Metropolitan Planning Commission

Staff Reports

February 28, 2008_B

**SPECIFIC PLAN
ZONING DISTRICTS**

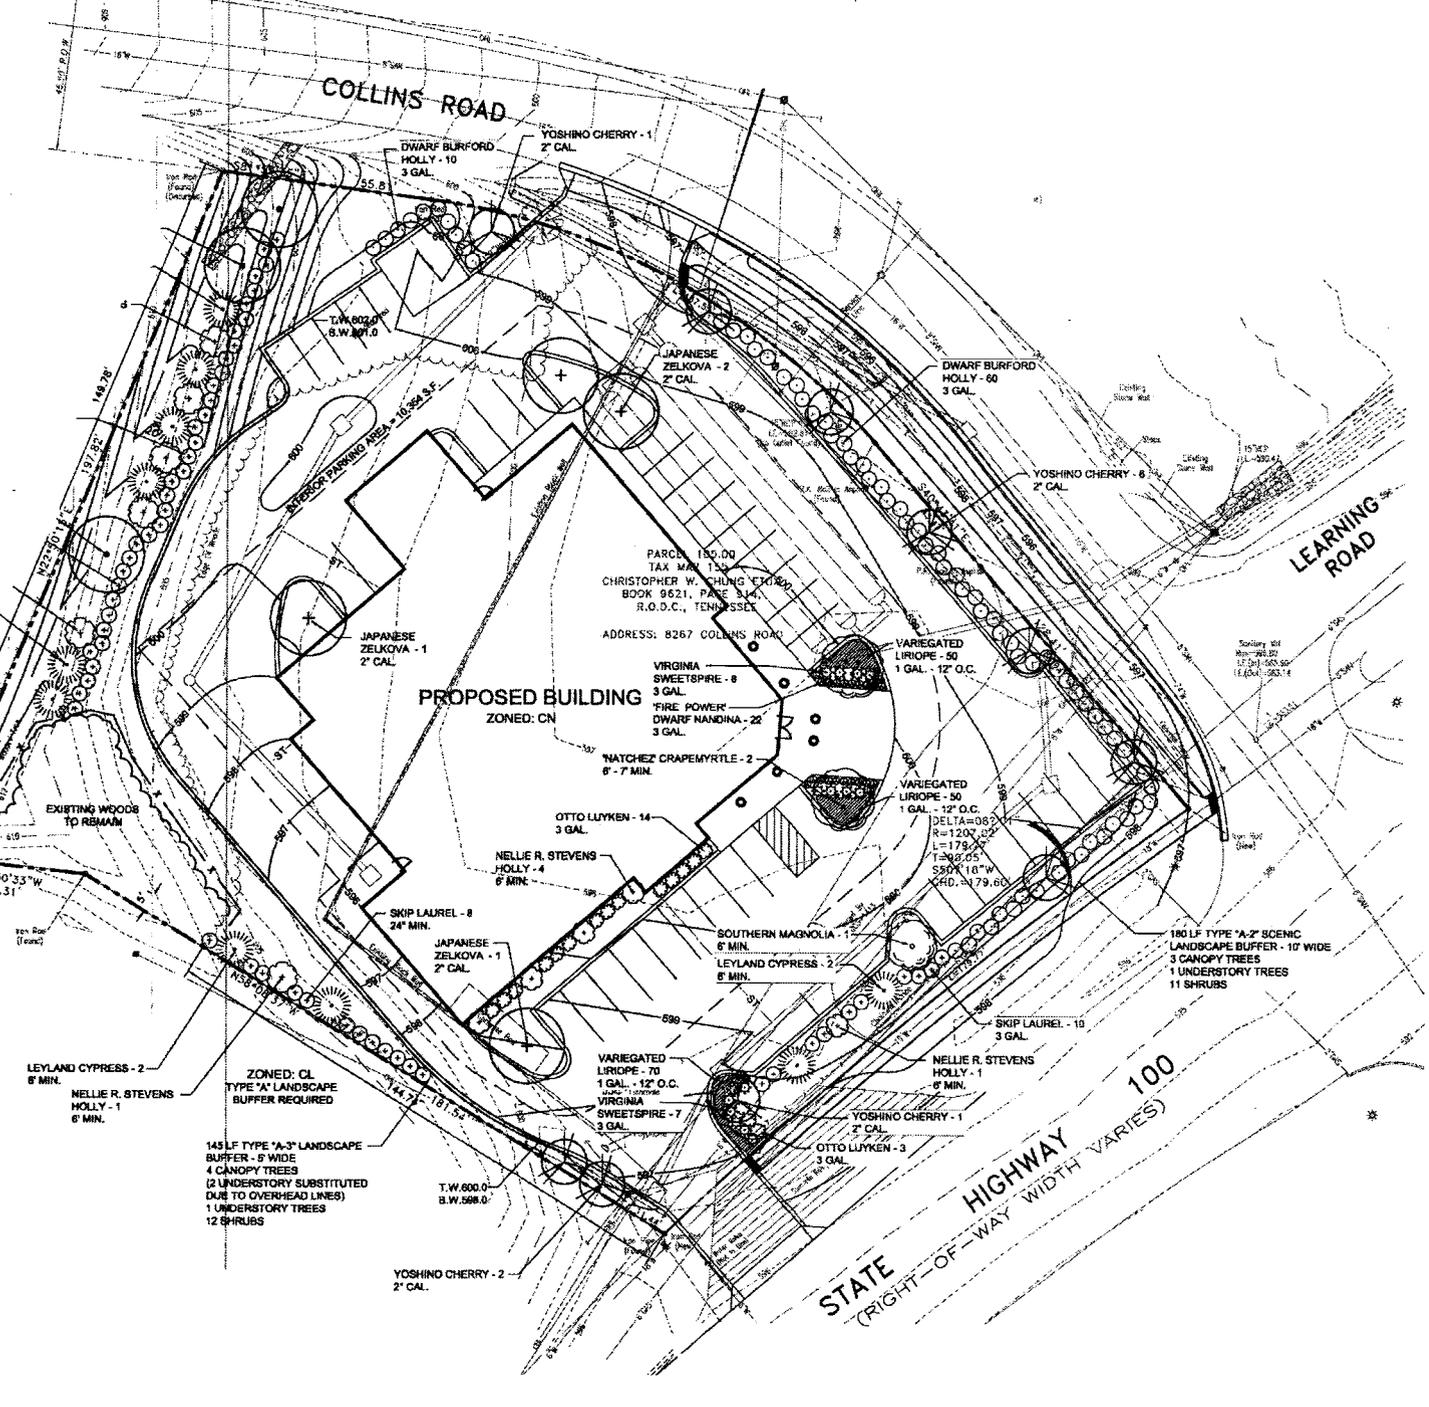
Show and dimension right of way along Collins Road. Label and dedicate right of way 30' from centerline to property boundary, consistent with the approved major street / collector plan.

Show and dimension right of way along Highway 100 at property corners. Dimension from centerline. Label and show reserve strip for future right of way, 50 feet from centerline to property boundary, consistent with the approved major street plan (S4 - 100' ROW).

Remove driveway connection from the Collins Road/ Learning Lane intersection.

1. According to Metro GIS information, the existing 15-inch RCP and headwall shown on the Demolition Plan C1.3 is a culvert diagonally crossing Collins Road. It terminates at the corner of Collins and Learning Road into the ditch on the north side of Learning Road. The Metro GIS information based on field information indicates that the size is actually 18-inch.
2. Add a note on the Erosion Prevention and Sediment Control (EPSC) Plan sheet requiring the contractor to provide an area for concrete wash down and equipment fueling in accordance with Metro CP-10 and CP-13, respectively. Contractor to coordinate exact location with NPDES department during preconstruction meeting.
3. Provide Final Stabilization measures for all disturbed areas on the final Grading and Drainage Plan, C3.1.
4. Provide final grading slopes 3:1 or greater with approved MWS erosion control matting.

5. Final Design Calculations to be stamped, signed and dated by a Tennessee P. E. The property survey provided did not have the surveyor's stamp.
6. The proposed 24-inch RCP culvert outlet is shown in different locations on sheets C2.1 and C3.1. The pipe on Sheet C3.1 extends to the water quality buffer of the receiving stream. If enclosure of the ditch is intended, MWS policy does not approve enclosure of an open ditch, exceptions include that the enclosure is due to a safety concern or the ditch capacity is extended.

7. Provide the discharge outflow velocity and include outlet protection detail.
8. The pipe size, material, and slope for the proposed pipe under Collins Road were not shown on the sheet C3.1.

9. The Sediment Trap storage volume must include 134 cubic yards per acre for settling and an additional 45 cubic yards per acres for sediment storage. The discharge must have outlet protection in place and shown on the EPSC sheet.

10. Sheet C2.1 drawing does not include the Underground Sand Filter. Underground detention structures from a previous design are shown.
11. The ditch located on the north side of the property should have side slopes of 3:1 or less. Provide geotextile lining to prevent erosion. Reference Metro Stormwater Manual, Volume 4, PESC-02. How will the ditch enter the existing roadside ditch?

12. The design calculations provided indicate three runs of Stormtech. The detention pipe system on sheet C3.1 appears to be two 48-inch pipes, 90 and 100 feet respectively.

13. For the drainage system including and through the underground detention pipes and sand filter, provide pipe flow, capacity, full flow velocity, Manning's n, pipe slope, and hydraulic grade line at each structure for the 10-year storm event. Provide a Drainage Table showing all structures. The drainage calculations provided only included three pipes and some sizes, lengths, and slopes listed do not match the information given on sheet C3.1.

16. Elevations of the inlet, temporary ponding, and permanent pool were not included in the Underground Sand Filter drawing. The elevations should be listed in the drainage system calculations. Provide the length dimension of the forebay (permanent pool).
